## ANN ARBOR HISTORIC DISTRICT COMMISSION

### Staff Report

**ADDRESS:** 335 S Seventh Street, Application Number HDC19-086

**REPORT DATE:** June 13, 2019

**Window Summary**

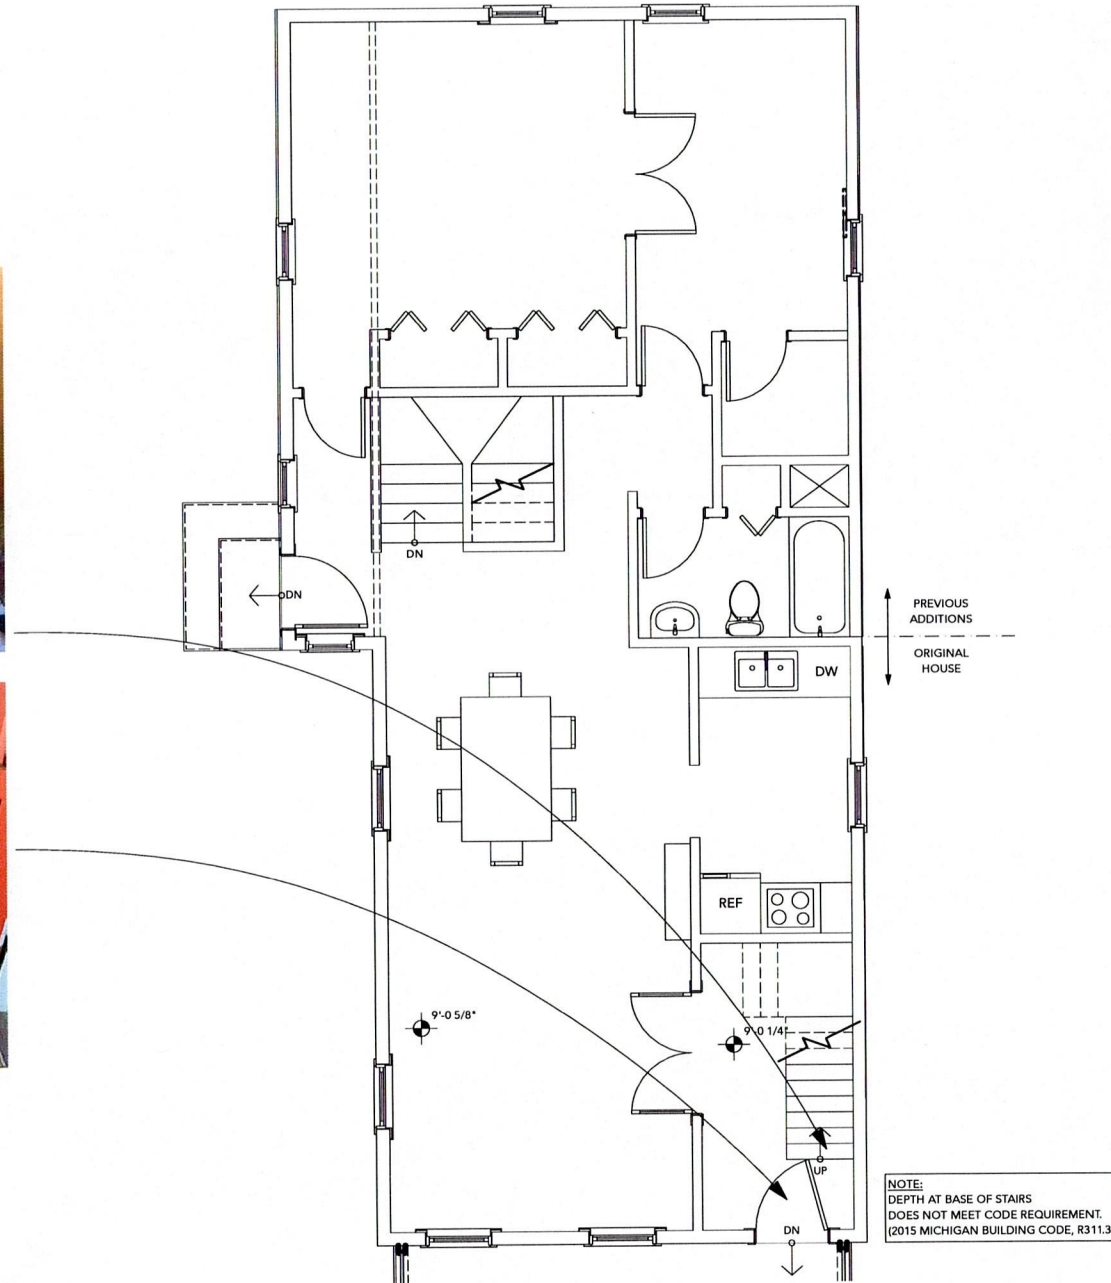
1. A summary of work is provided on sheet A0.04 of the application packet. The work on the large rear addition -- adding, moving, and replacing windows -- does not detract from the historic portion of the house, and staff believes it is appropriate. Similarly, replacing one second-floor street-facing non-original window with the same is appropriate.
2. On the south elevation of the original part of the house, an original opening near the rear

South Elevation - Existing

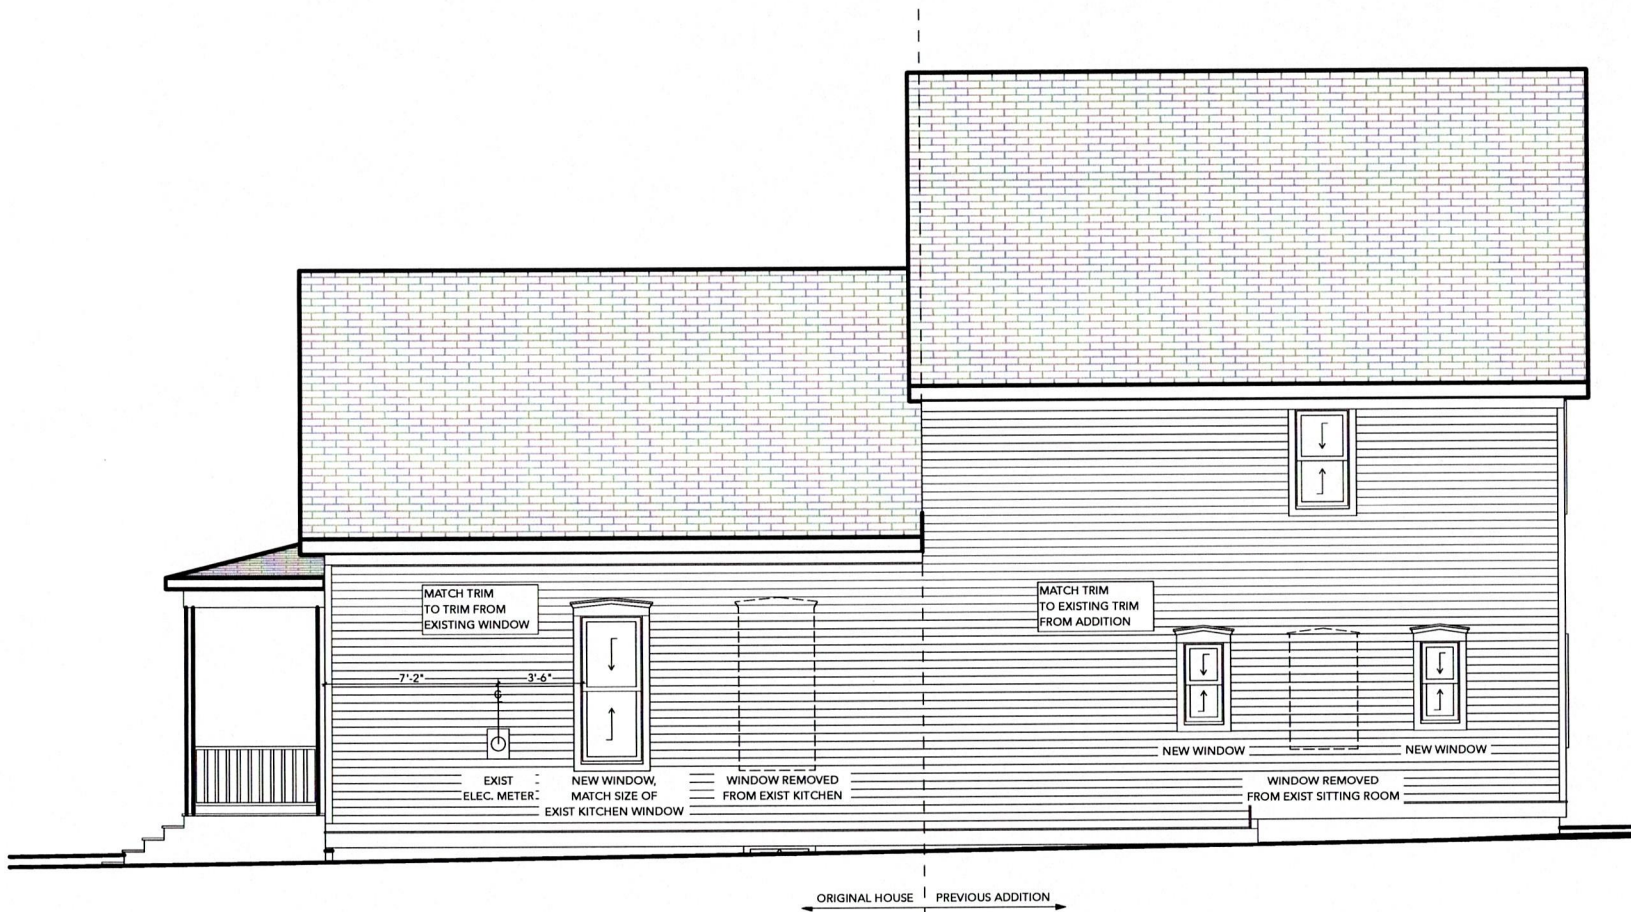
of the first floor is proposed to be moved forward about 6'. The non-original clad double-hung window would be replaced with the same. The window is proposed to move because an interior staircase at the front door is being pushed back farther to allow the front door to fully open. It is usually not appropriate to move a window, but the lack of an adequate stair landing and the solution to that problem (pushing back the stair, which would then interfere with the window) should be considered. The window trim is proposed to match the historic window trim, which staff finds acceptable since the window will retain its opening size and general location on the house.

3. Staff believes the proposal meets the standards and guidelines followed by the HDC, and recommends approval of the application.
